Access Compliance Report

Public Rights-of-Way (Curb Ramps)

Intersection ID: 52443	Main Street: WILLOW_GREEN_PL	Cross Street: BENDING_BIRCH_PL	Location: SW
ADA ID: 4BC269D400F3	Ramp Type: Directional1	Initial Pass/Fail: Fail	Overall Compliance: No
			Severity Score: 13.75

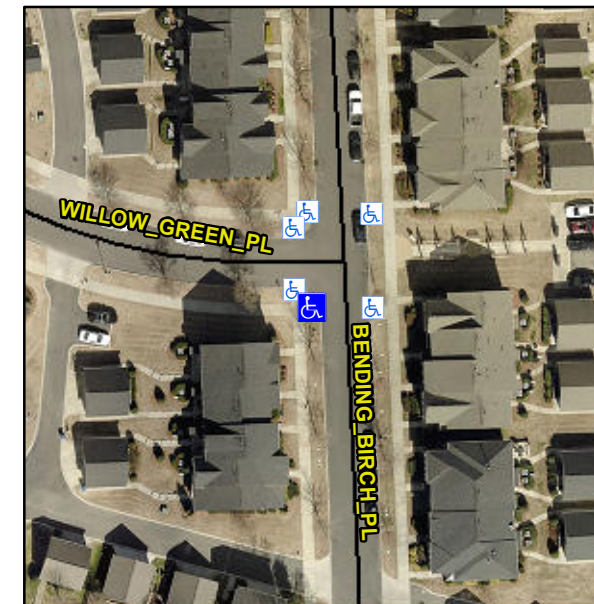
R304.2.2, R304.5.3

Compliance	Description	Data	Compliance	Description	Data
N/A	Ramp Length (in)	79.0	N/A	Grade Break?	N/A
Yes	Ramp Width (in)	68.0	N/A	Grade Break Slope (%)	0.0
No	Ramp Slope (%)	10.1	N/A	Grade Break XSlope (%)	0.0
No	Ramp XSlope (%)	4.2			
N/A	Flare Type LT	N/A	N/A	Flare Type RT	N/A
N/A	Flare Slope LT (%)	N/A	N/A	Flare Slope RT (%)	0.0
N/A	Flare Traversable LT?	N/A	N/A	Flare Traversable RT?	N/A
N/A	Landing Length (in)	0.0	N/A	DWS Provided?	N/A
N/A	Landing Width (in)	0.0	N/A	DWS Contrast?	N/A
N/A	Landing Slope (%)	0.0	N/A	DWS Length (in)	N/A
N/A	Landing X Slope (%)	0.0	N/A	DWS Full Width?	N/A
N/A	Landing Curb? (Y/N)	N/A	N/A	DWS Offset LT (in)	N/A
N/A	Shared Landing?	N/A	N/A	DWS Offset RT (in)	N/A
N/A	Gutter Ponding?	0.0	N/A	Gutter Slope (%)	N/A
N/A	Gutter Lip Ht (in)	0.0	N/A	Gutter X Slope (%)	N/A
N/A	Painted X Walk1?	No		Road Slope (%)	6.8
	X Walk 1 Direction	To E		Road X Slope (%)	0.9
	X Walk 1 Width (in)	N/A		Clear Space?	N/A

Remove & Replace Entire Ramp.
